Project Name: Panera
 Description: Final site plan approval and PDA recommendation
 Date on Agenda this packet pertains to: January 16, 2025

RE: Panera Bread and Retail Development- Preliminary Site Plan Review – 4th Review

RE: Panera Bread
Preliminary Site Plan – Review #3

DRAWING: **C-3**

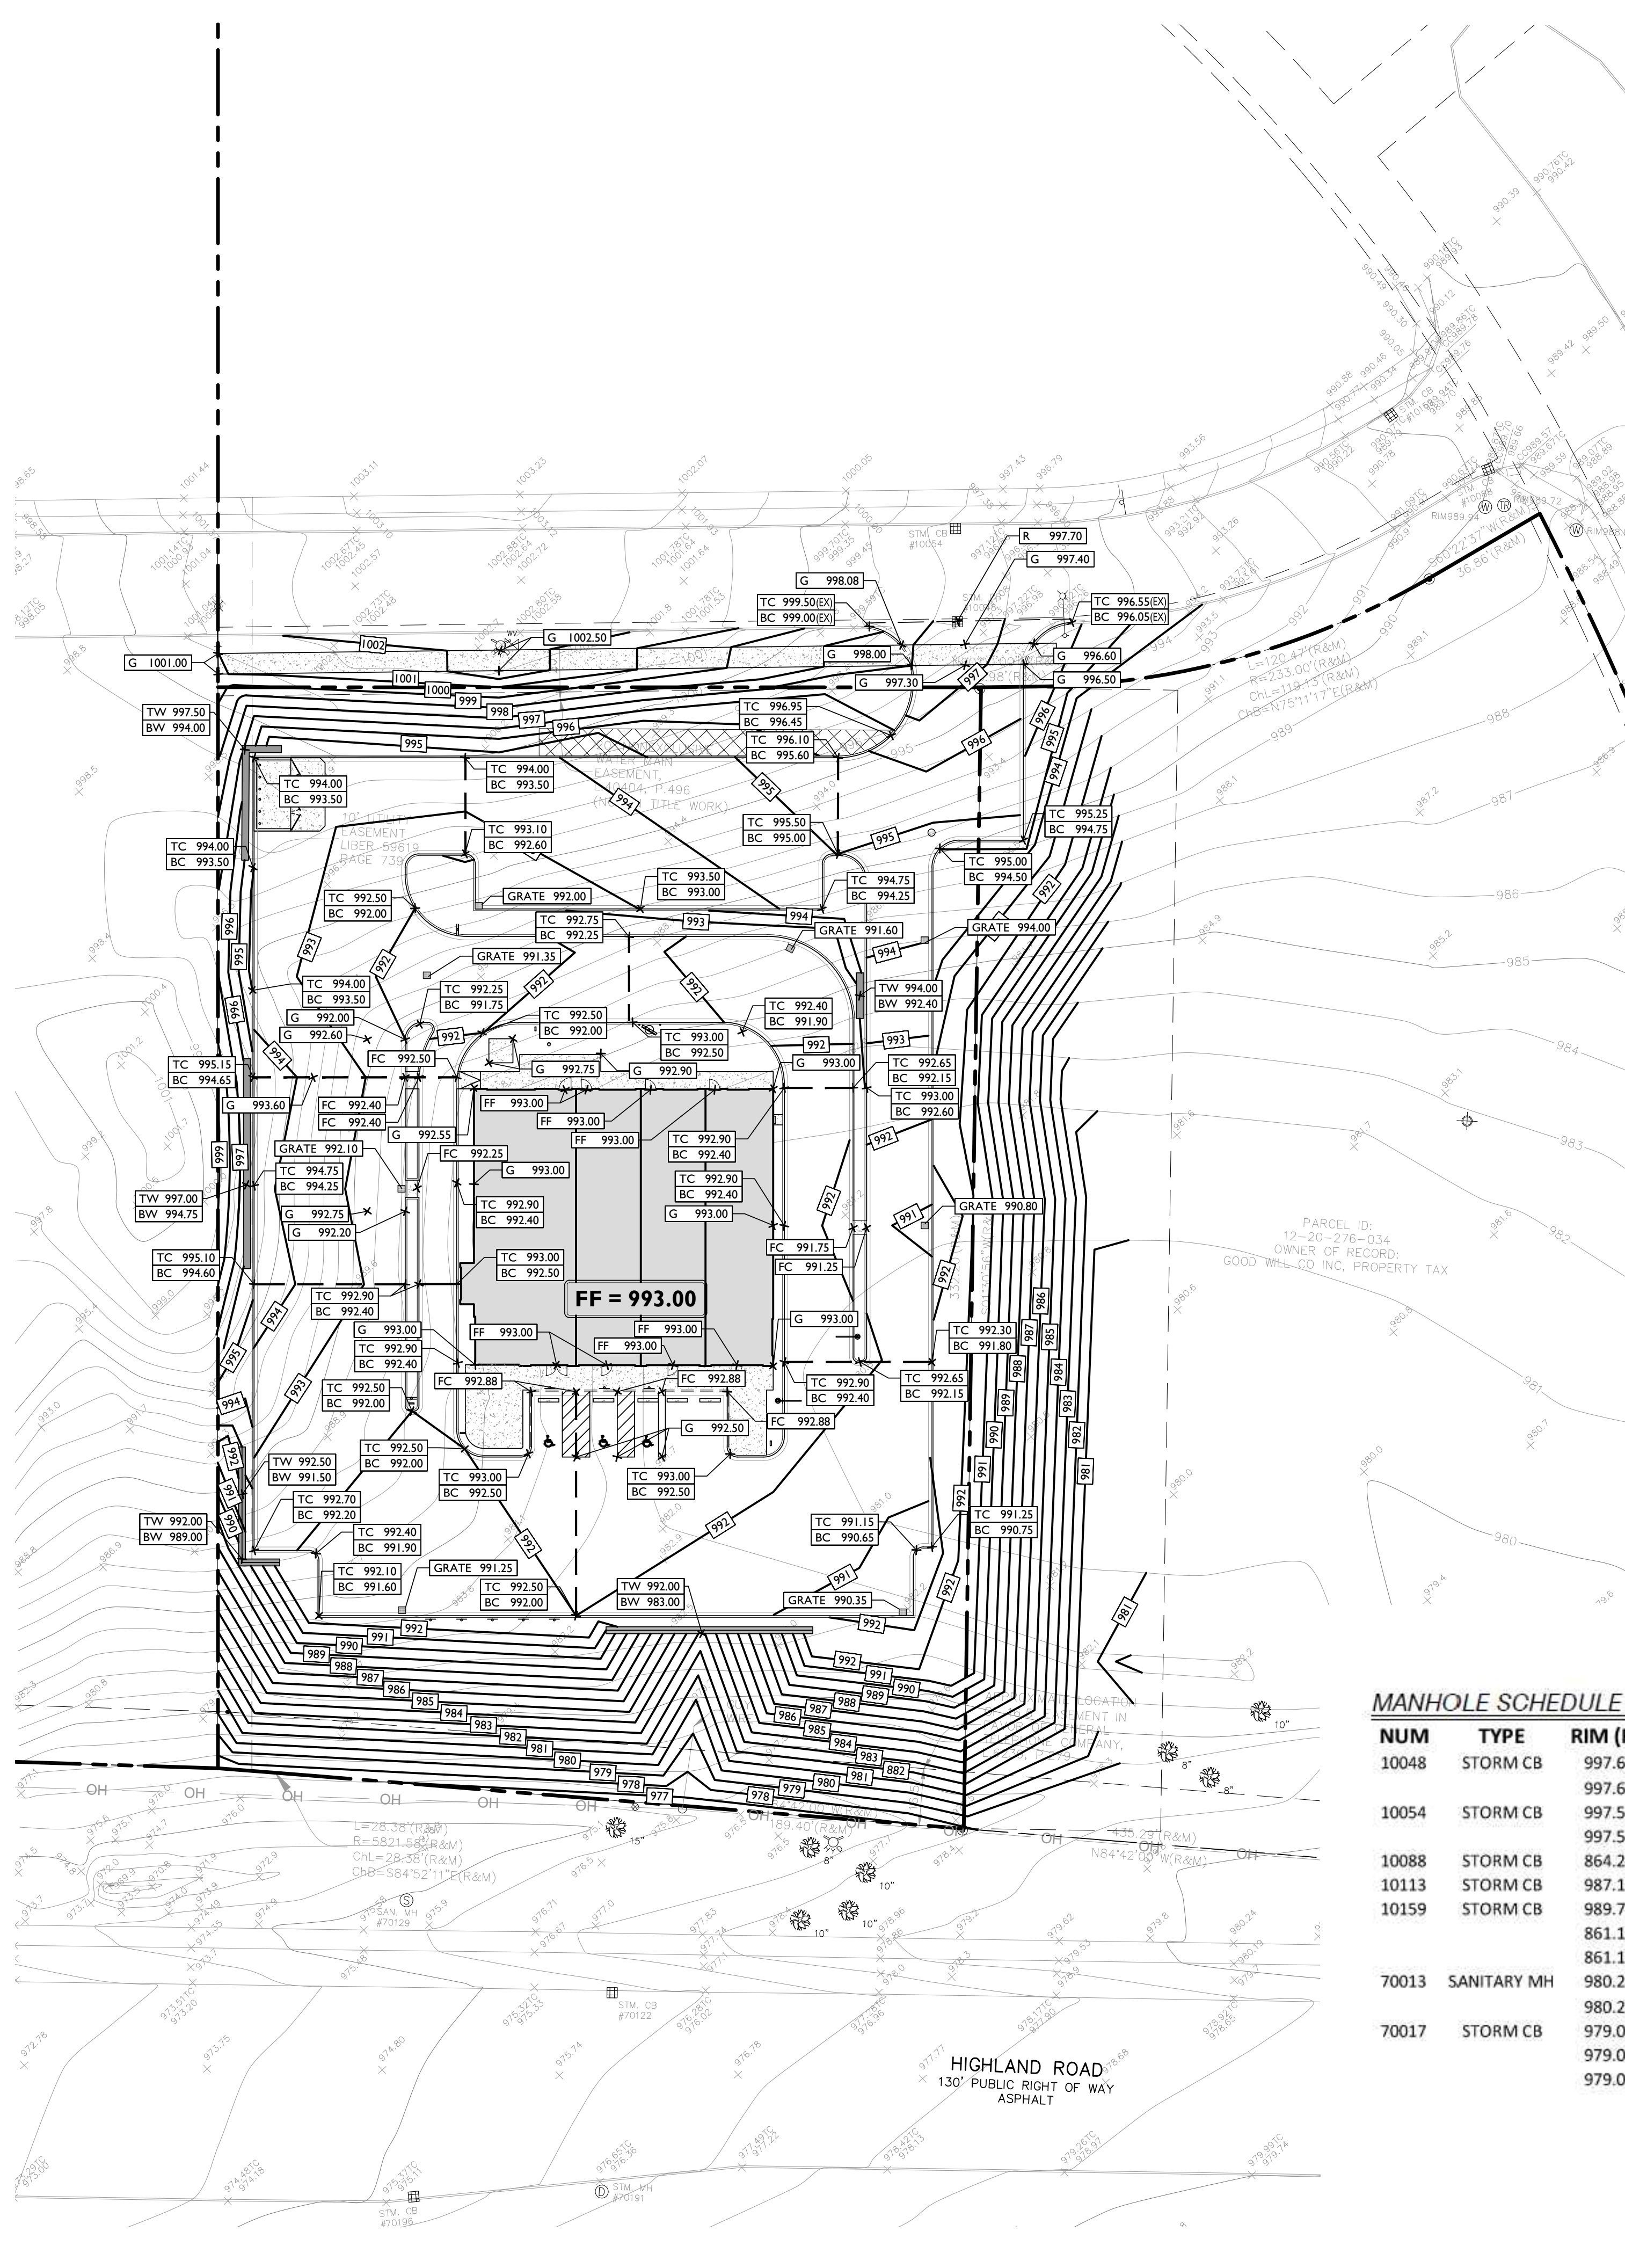
- j) The proposed one-way drive on site is now shown as 17' in width. A minimum 20' width is required per Township Zoning Ordinance 5.11.Q v. We defer to the Township Planning department if a variance will be required for this drive width.

The Fire Truck Turning Exhibit (Sheet C-13) indicates a fire truck traversing over a curb, landscaping, a snow storage area, a sidewalk, and another curb to exit the site. Driving outside of designated fire lanes is not, pursuant to the zoning ordinance, acceptable for the efficient and effective use of fire apparatus (likely also noncompliant with the Fire Code). Sheet C-13 shall be revised to demonstrate fire apparatus can enter and exit the site by utilizing drive aisles/maneuvering lanes and the site driveway. Fire truck circulation is now shown on Sheet C-14. We defer to Township Public Safety on the validity of the proposed circulation however we note that there may be issues for emergency vehicles utilizing the one-way drive to the east of the building. The one-way drive aisle has been reduced in width from 20 feet to 17 feet. This does not conform to the Section 5.11.Q.v requirement that one way drive aisles be 20 feet wide. This should be corrected in the revised plan.

All dimensions for drive widths and parking space depth shall be revised. The site plan measures drive widths to the back or face of curb; road measurement surface is taken between the edges of the gutter pan (drive width shall be provided between the edges of the gutter pan). (Comment outstanding. Drive aisle width shall exclude the gutter pan). Furthermore, gutter pan shall not be included in the measurement of parking space depth. (Comment partially addressed. Excluding the gutter pan from stall dimensions results in a minimum proposed standard space of 9' x 18', which is compliant with the zoning ordinance. Revise the proposed column for Section 5.11.Q within the Off-Street Parking Requirements Table to reflect 9' x 18' spaces. The barrier-free spaces shall be revised to exclude gutter pan from the width of the spaces). Provide a note on Sheet C-3 stating such. (Comment outstanding). (Comment addressed).

A snow storage plan was not provided. Information on method of snow storage shall be provided (denote snow storage areas on Sheet C-3). (Comment addressed. A snow storage area has been indicated on Sheet C-3). Winter maintenance of parking lot landscape islands shall be required where heavy applications of salt and de-icing products occur through the use of salt tarps which minimize soil absorption and ultimately reduce plant disorders. (Comment addressed. A maintenance note has been added to Sheet C-8).

The proposed enclosure is located northwest of the building. The zoning ordinance prohibits trash enclosures within a required front yard setback, and does not allow enclosures closer to the front lot line than the principal building. The proposed dumpster enclosure is located closer to the Meijer private drive than the building and within the front yard setback. **A waiver is required to allow the dumpster enclosure to project into the front yard and a waiver is required to allow the dumpster enclosure to encroach into the front yard setback.** (Comment outstanding. **Waivers have been requested by the Applicant.** Per comments regarding the north elevation of the building and its relation as dual frontage property, we recommend additional landscaping screening be proposed around the dumpster enclosure in lieu of a waiver for placement.

The trash enclosure detail on Sheet C-9 shall be revised to be consistent with Sheet C-3 which shows partitioning wall(s) separating the southerly third of the enclosure from the northerly two-thirds of the enclosure. Sheet C-3 shall include labels to note the type of bins to be placed in each portion of the enclosure (Comment addressed).

C-4

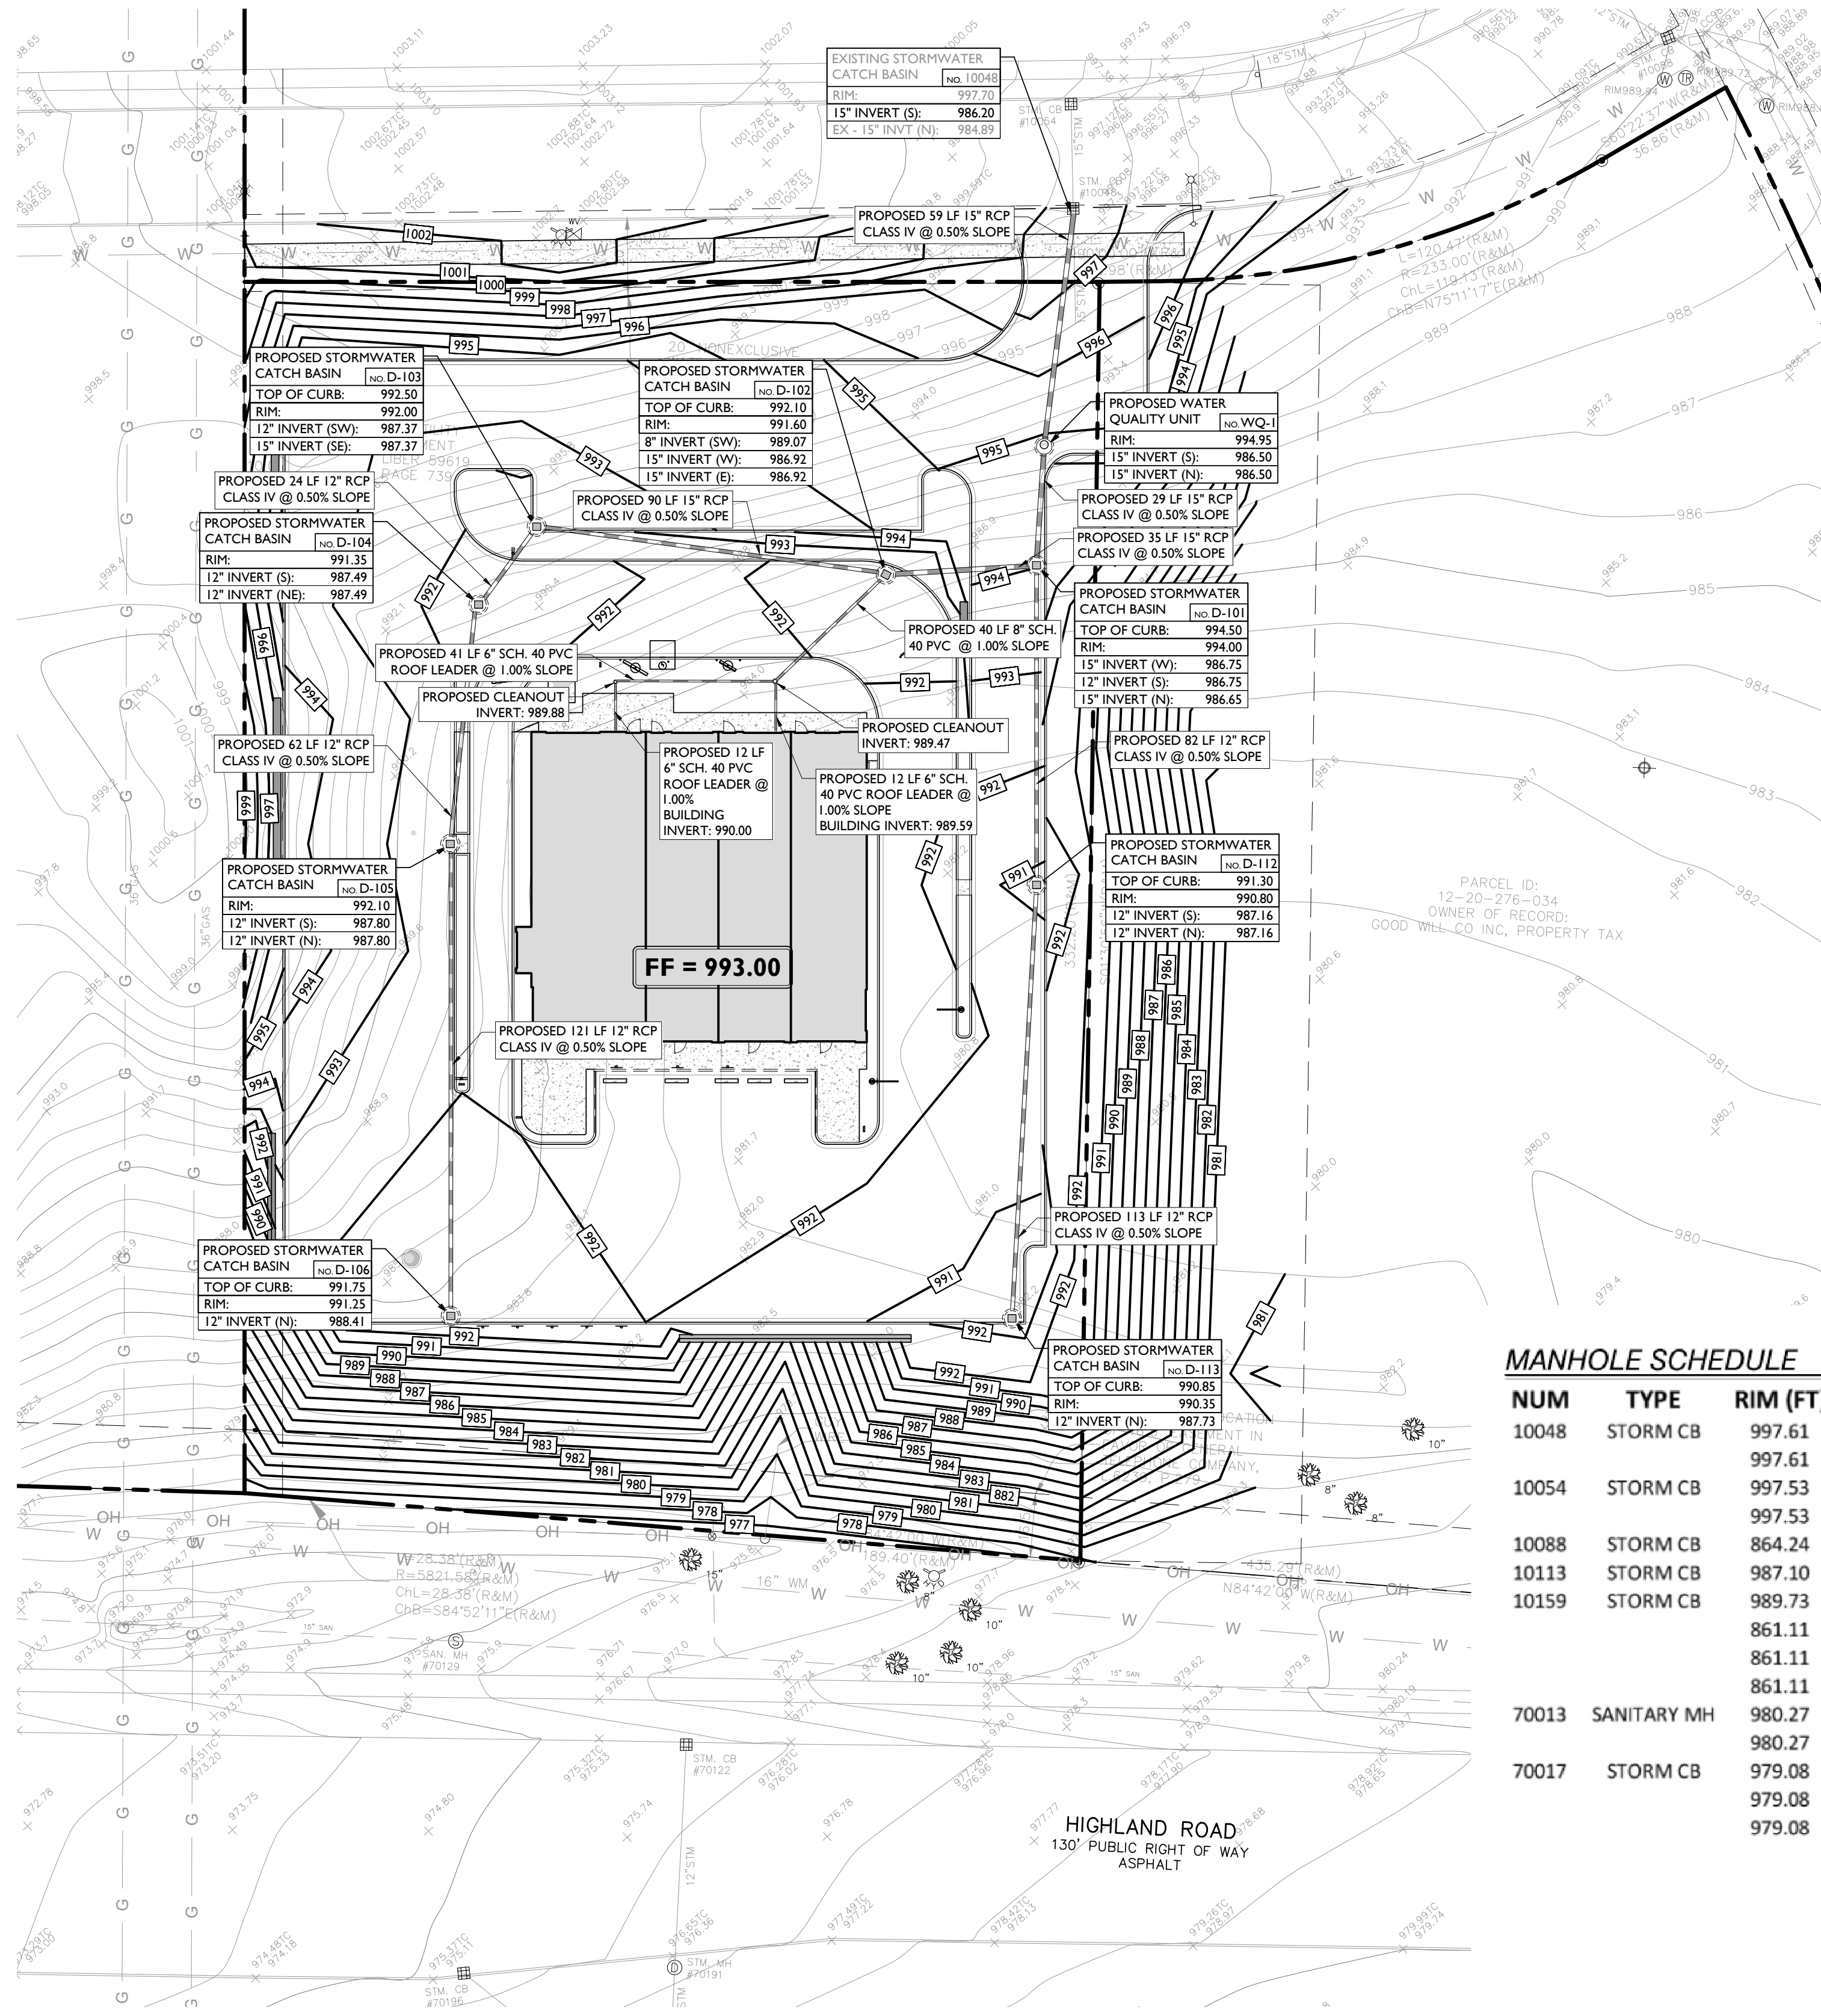
- e) *Preliminary grading of the site has been proposed and demonstrates general drainage patterns; we note that the proposed 997 contour near the northwest corner of the site will result in ponding of water with no positive outlet. We further note that the wall grades on the south of the property are off in elevation with a top of wall grade 40 feet below the bottom. Please note that retaining walls over 30" in height will require a decorative railing. Please revise. Comment partially addressed. A yard inlet has been provided at the low point. In addition, proposed wall height elevations have now been adjusted. Please add a note regarding the requirement for decorative fencing at the top of the wall. **A note regarding the installation of a guardrail at the top of the retaining wall has been added to Sheet C-3. A detail of the guardrail shall be required at the time of FEP submittal. In addition, please add a guardrail note to the wall that is proposed next to the dumpster. A guardrail is required for this wall as it exceeds 30" in height.***

- h) Offsite grading is proposed on the property to the east. The design engineer has noted that a temporary grading easement is to be obtained and can be provided at the time of Final Engineering Plan (FEP) submittal.
